Access Compliance Report

Public Rights-of-Way

(Curb Ramps)

Intersection ID: 11095	Main Street: ASHLEY_RD	Cross Street: LIGGETT_ST	Location: N
ADA ID: 7F860630599E	Ramp Type: Perp	Initial Pass/Fail: Fail	Overall Compliance: No
			Severity Score: 21.25

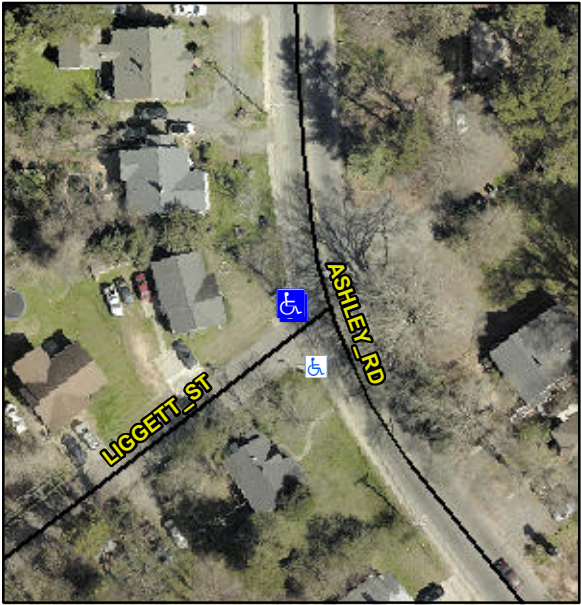
Codes/Mitigation Info/Possible Solution			Field Measurements/Component Compliance		
	Possible Solutions:		Compliance	Description	Data
	Remove & Replace Entire Ramp.		N/A	Ramp Length (in)	57.0
			No	Ramp Width (in)	46.0
			N/A	Flare Type LT	N/A
			N/A	Flare Slope LT (%)	N/A
			N/A	Flare Traversable LT?	N/A
			N/A	Landing Length (in)	N/A
			N/A	Landing Width (in)	N/A
			N/A	Landing Slope (%)	N/A
			N/A	Landing X Slope (%)	N/A
<p>Surveyor Notes:</p> <p>N/A</p> <p>PROW/ADA:</p> <p>R304.5.1, R304.2.2</p>			N/A	Flare Type RT	N/A
			N/A	Flare Slope RT (%)	N/A
			N/A	Flare Traversable RT?	N/A
			N/A	DWS Provided?	N/A
			N/A	DWS Contrast?	N/A
			N/A	DWS Length (in)	N/A
			N/A	DWS Full Width?	N/A
			N/A	DWS Offset (in)	N/A
			N/A	Shared Landing?	N/A
			N/A	Gutter Ponding?	N/A
			N/A	Gutter Lip Ht (in)	N/A
			N/A	Painted X Walk1?	No
				X Walk 1 Direction	To S
			N/A	X Walk 1 Width (in)	N/A
				X Walk 1 Slope (%)	1.9
				X Walk 1 X Slope (%)	0.1

N/A	Ramp inside XWalk1?	N/A
			N/A	Road Slope (%)	N/A
			N/A	Road X Slope (%)	N/A
			N/A	Any Obstructions?	N/A
				Obstruction Type	
Total Cost:			\$	1850.00
